# PREVOST

## WARRANTY BULLETIN

### WB15-10A

| SUBJECT :   | ENGINE OIL FLEXIBLE TUBE INSPECTION<br>AND REPLACEMENT |           |             |

Figure 1

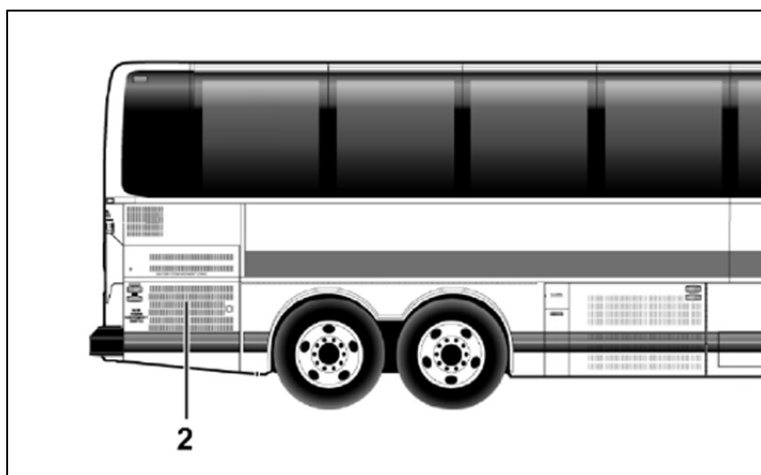
- Open curb side engine compartment door. (Item 2, Fig. 1)
- Visually inspect the lowest section of the oil fill tube. (Fig. 2) The hose connecting the steel tube to the oil pan should be green or blue. (Fig 3 & 4)
- If hose is black, perform replacement according to Step **B** below. Otherwise, this is the end of the bulletin.

Figure 2

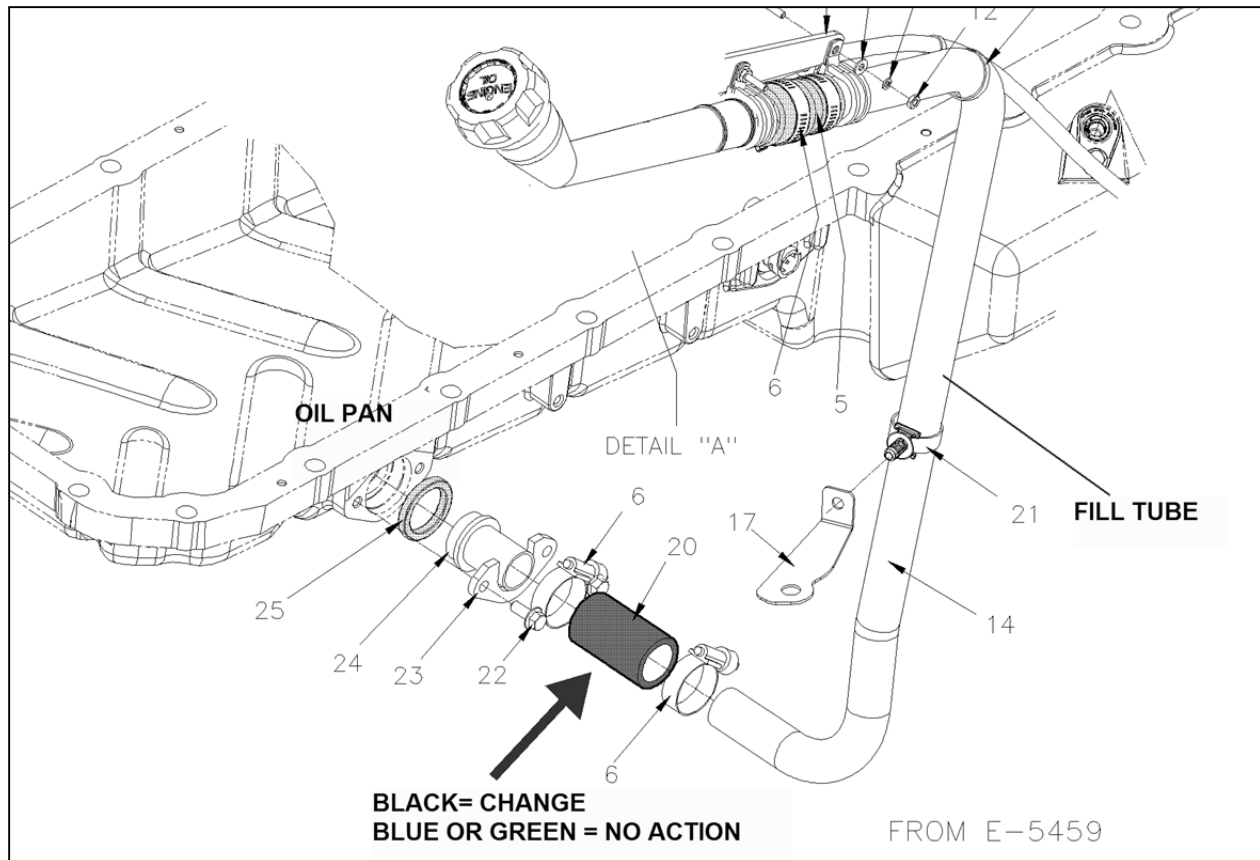
- 2) Using two mobile column lifts, jack vehicle about 38 cm (15 in) by drive axle to allow oil to move to the forward section of the oil pan.
- 3) Use a suitable container to collect any remaining oil that may drip while performing replacement.
- 4) Perform tube removal by undoing the two clamps. (Fig. 2) Dispose of tube according to regulations.
- 5) Install new tube 012933. Tighten clamps to 3,4 N-m (30 lbf-in).
- 6) Apply a torque seal of different color from the original seal to clearly mark change.
- 7) Lower vehicle. Confirm proper operation. Confirm installation is oil tight.

Figure 5

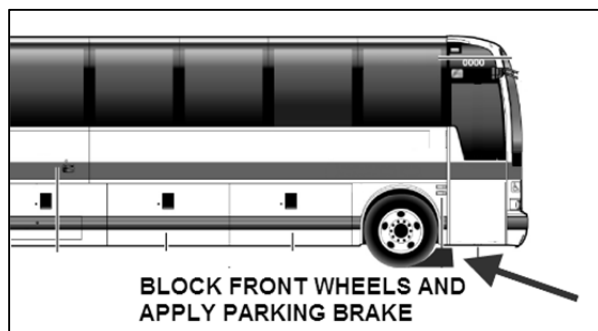
- 1) Apply parking brake and block front wheels.(Fig. 5)
